Subject: Supplemental Information Regarding Response to Request for Additional Information

Bellefonte Nuclear Plant, Unit 1 and 2
Construction Permits Nos. CPPR -122 and CPPR-123
NRC Docket Nos. 50-438 and 50-439

Nuclear Development, Inc.'s
Supplemental Response to NRC Information Request

Figure 1 – Bellefonte Project Organization

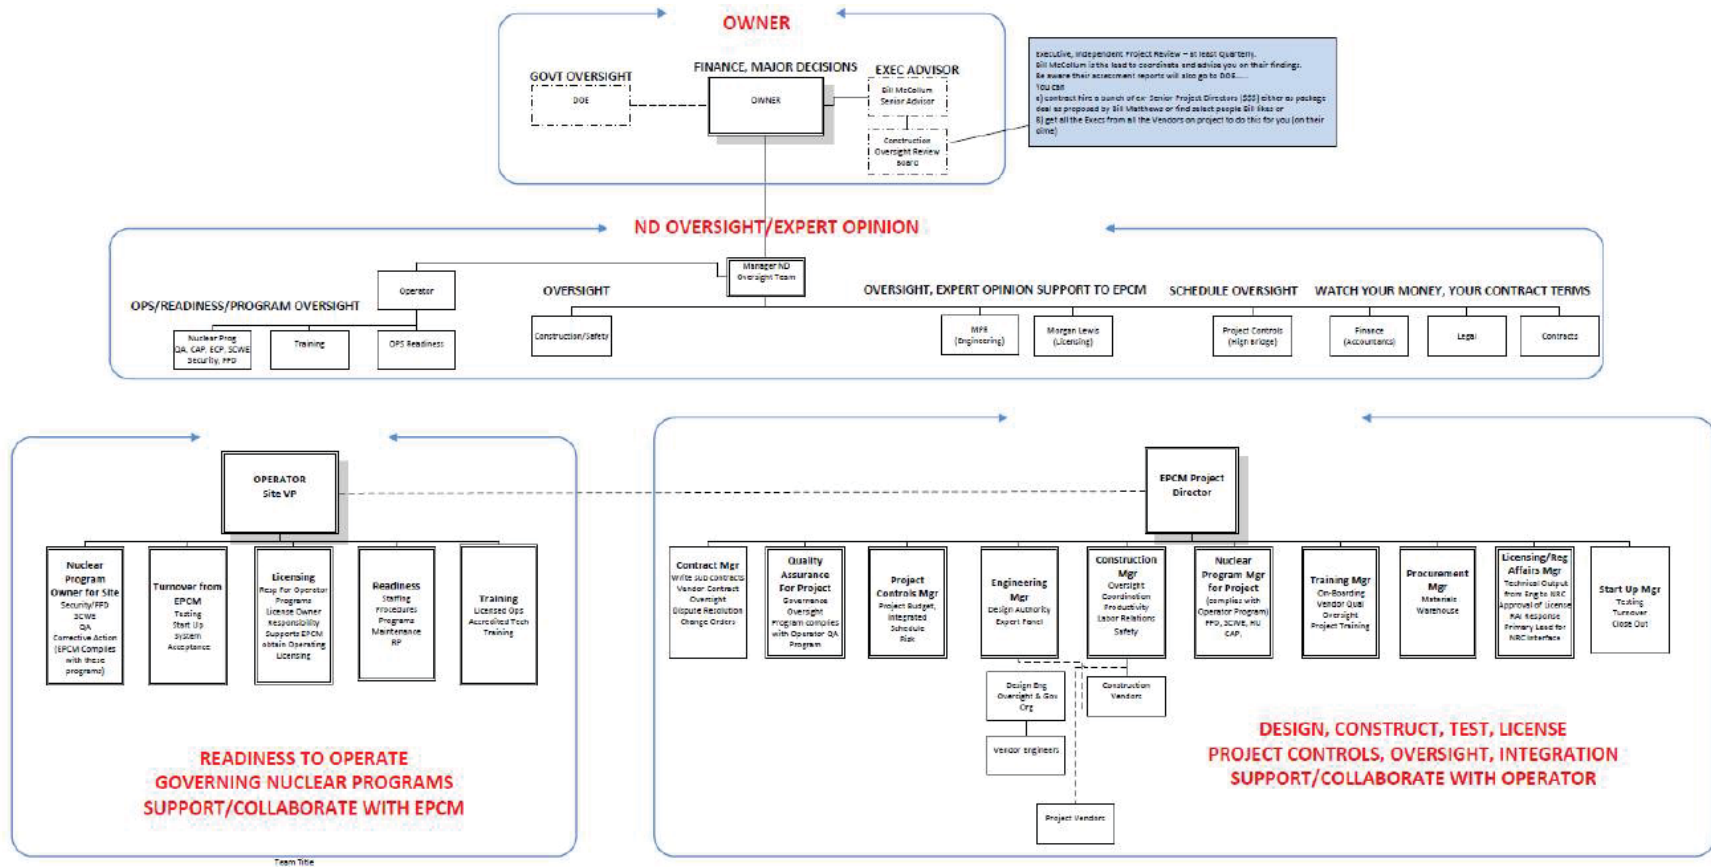
In order for the NRC staff to make a finding regarding the acceptability of ND's proposed Operating Element of the organization, the staff needs sufficient information regarding the technical qualifications, experience, and expertise of the Operating Contract partner. The NRC staff requested ND to supplement its RAI response and provide additional information regarding the identity of the Operating Contract partner and its technical qualifications, experience, and expertise.

The NRC staff explained that in accordance with Title 10 of the Code of Federal Regulations (10 CFR) 50.80(b), an applicant for a CP or operating license transfer shall include as much of the information described in 10 CFR 50.33 and 10 CFR 50.34 with respect to the identity, technical, and financial qualifications of the proposed transferee as would be required by those regulations if the application were for an initial CP. The staff further explained that in evaluating ND's response to RAI Question 1.e, the staff reviewed the information that the current operating reactor licensees had provided in their CP applications regarding the preliminary plans for operating organization, training of personnel, and conduct of operations, per 10 CFR 50.34(a)(6). The NRC staff stated that, as required by 10 CFR 50.80(b), the level of information that ND needs to provide in its CP transfer application regarding the operating organization, training of personnel, and conduct of operations should be commensurate with what would have been required of ND if it were submitting an initial CP application. The NRC staff requested ND to supplement its response to RAI Question 1.e accordingly.

The Bellefonte Project Organization from the Project Execution Plan is shown in Figure 1 below. The division of responsibilities for major functions is shown in Table 1. This table illustrates the relationships between the EPCM partner, Operations partner, and ND. Both Figure 1 and Table 1 are taken from the ND Project Execution Plan included in the ND response to NRC Requests for Additional Information dated August 28, 2019. Interfaces between project functions and organizations will be managed by site, ND, and EPCM procedures.

It is important to note that the ND plans for project oversight have evolved since the April 16, 2020 meeting. ND commits that personnel from SNL and Framatome will not be part of the ND project oversight organization. This will preserve independence between ND and those partners/contractors.
